SECTION 009113  
ADDENDUM NUMBER 3

- 1.1 DATE: December 29, 2021
- 1.2 PROJECT: Orangetown Town Hall Addition and Alterations
- 1.3 Owner: Town of Orangetown
- 1.4 Architect: Lothrop Associates LLP Architects

4 DOUBLE CHECK VALVE PART PLAN  
SCALE: NOT TO SCALE

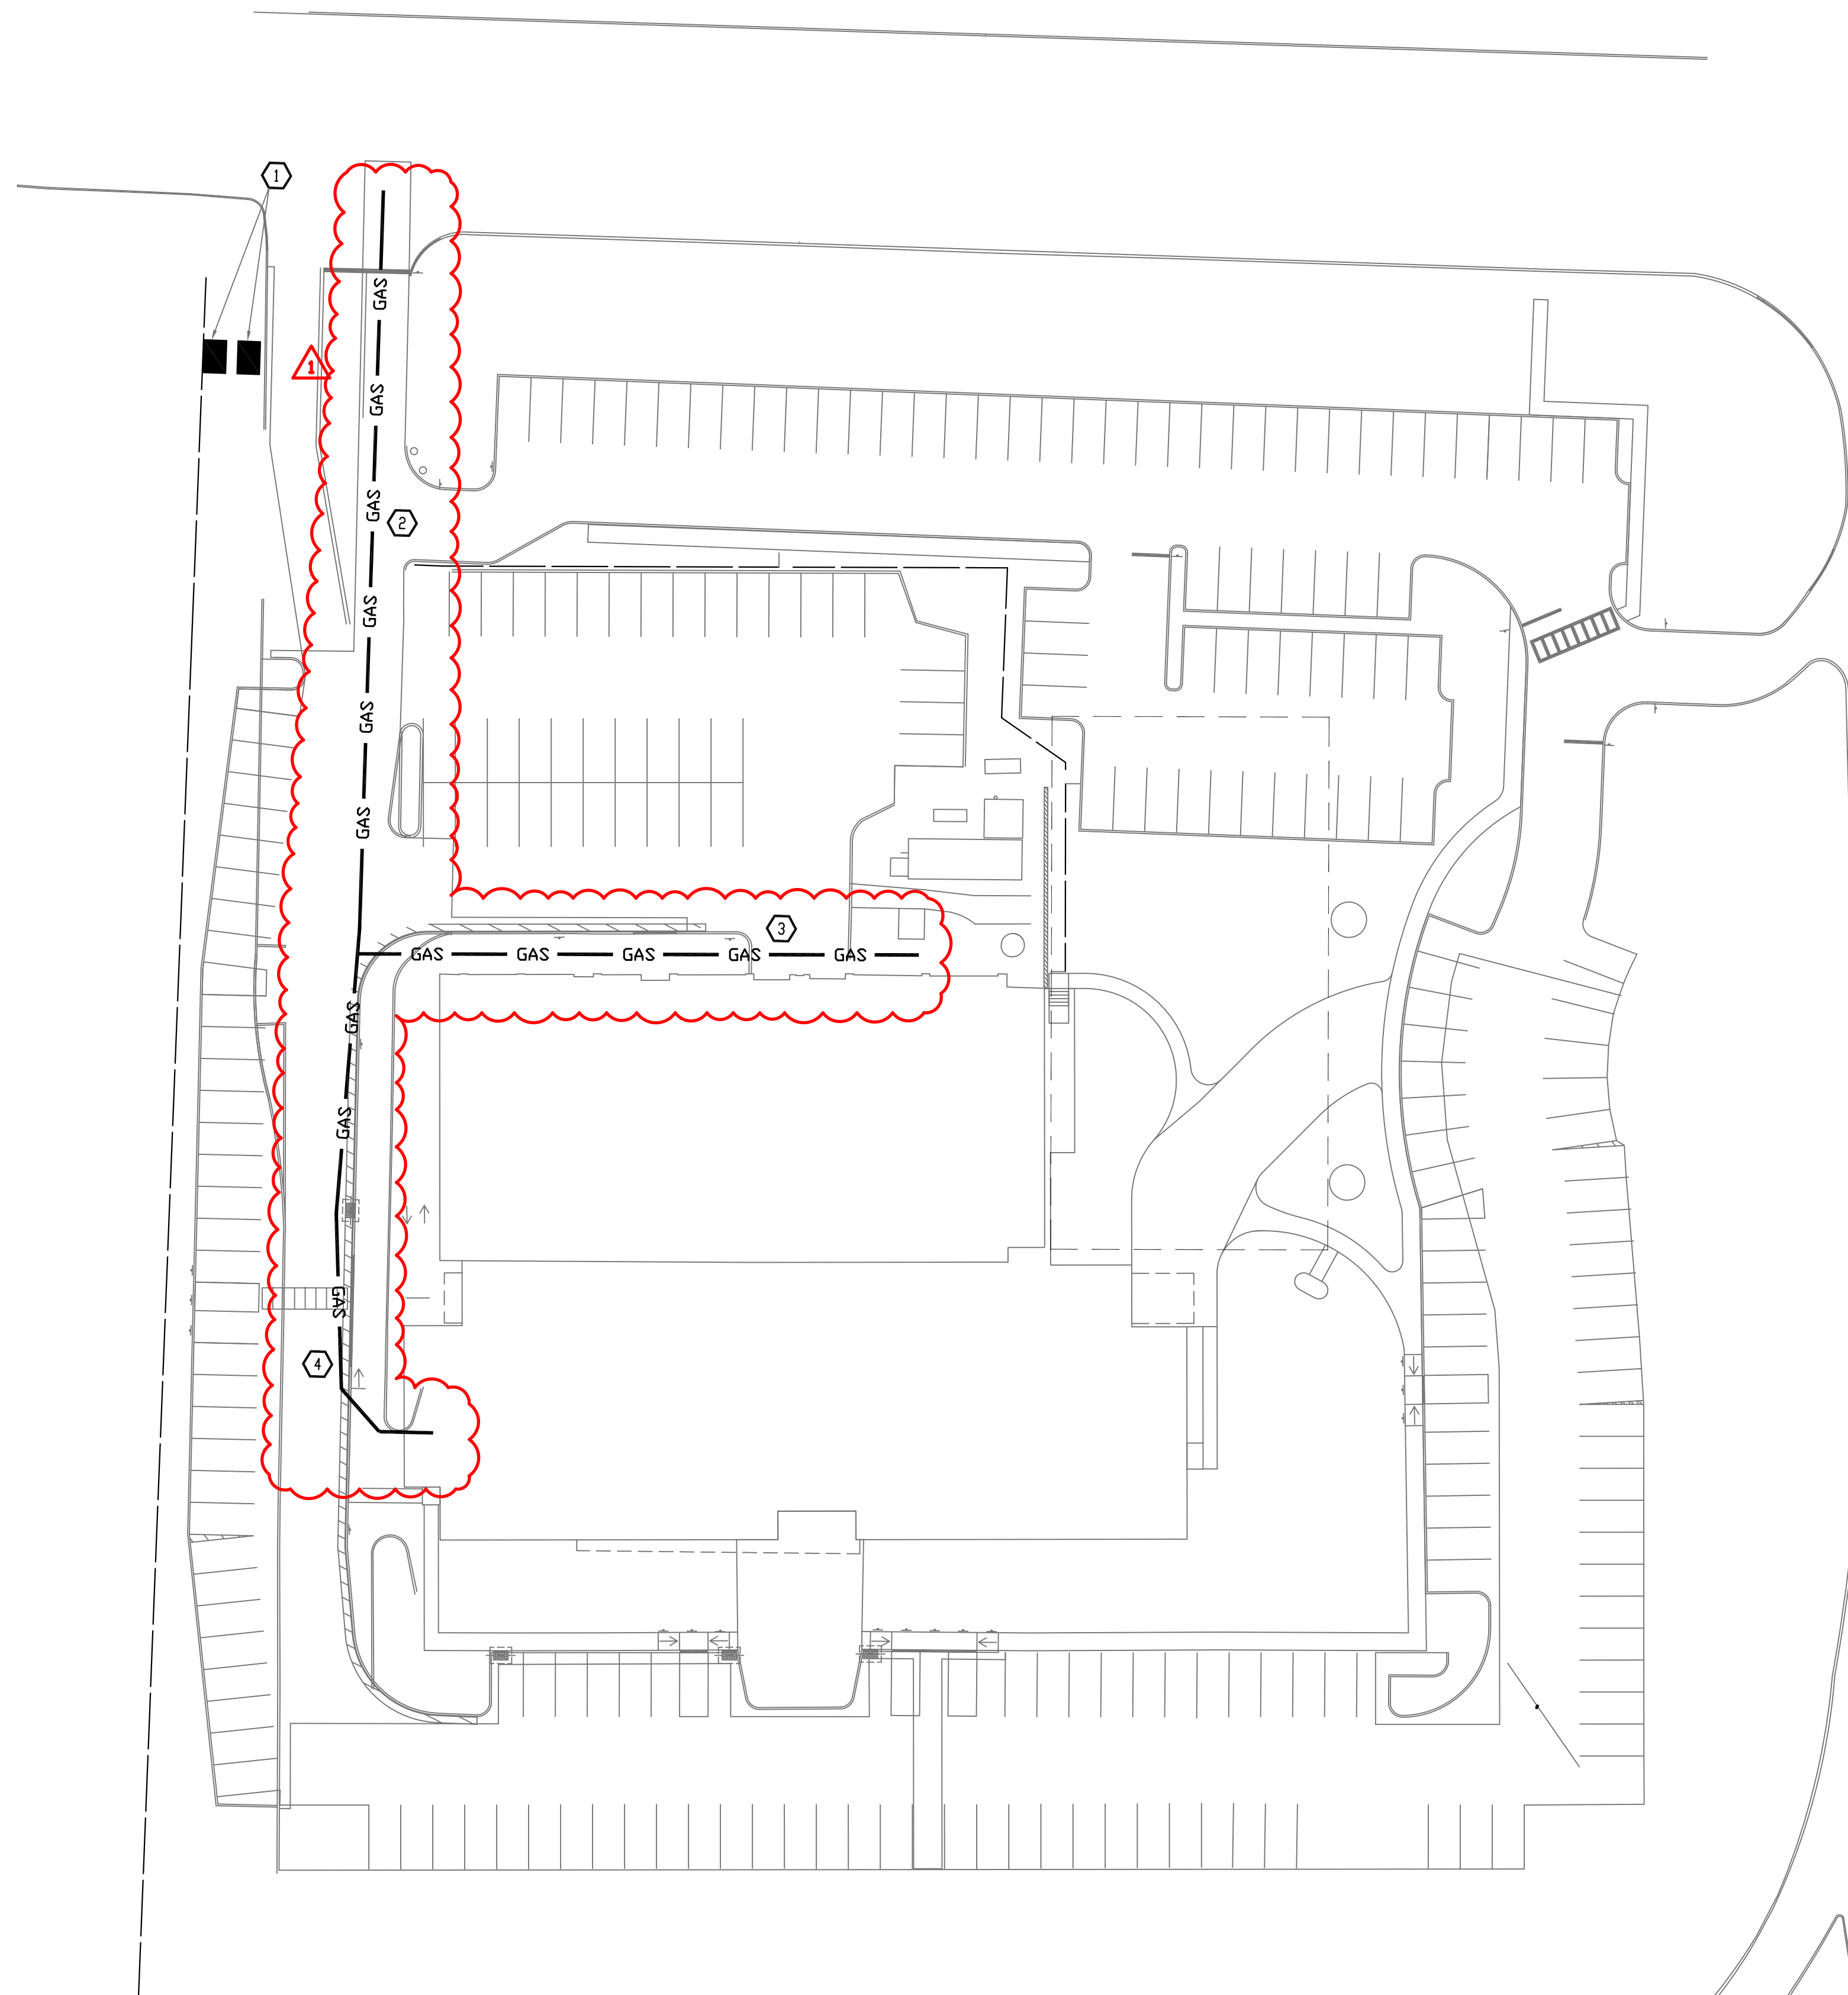
45. Please clarify the responsibility for the gas piping work on site. (Architect's RFI #1G.08)
- a. **The Plumbing Contractor is responsible for the installation of gas piping on site. See revised drawing P-206, attached to this Addendum.**

- APPROXIMATE LOCATION OF DOUBLE CHECK VALVE AND RPZ ON SITE. FOR ACTUAL LOCATION SEE SITE PLAN.
- NEW 2" GAS PIPING IN TRENCH PROVIDED UNDER THE GENERAL CONSTRUCTION WORK. COORDINATE CONNECTION TO NEW GAS SERVICE WITH UTILITY COMPANY.
- CONNECT NEW GAS PIPING TO EXISTING METER STATIONS FOR AT&T AND VERIZON GENERATORS.
- NEW GAS SERVICE INTO BUILDING.
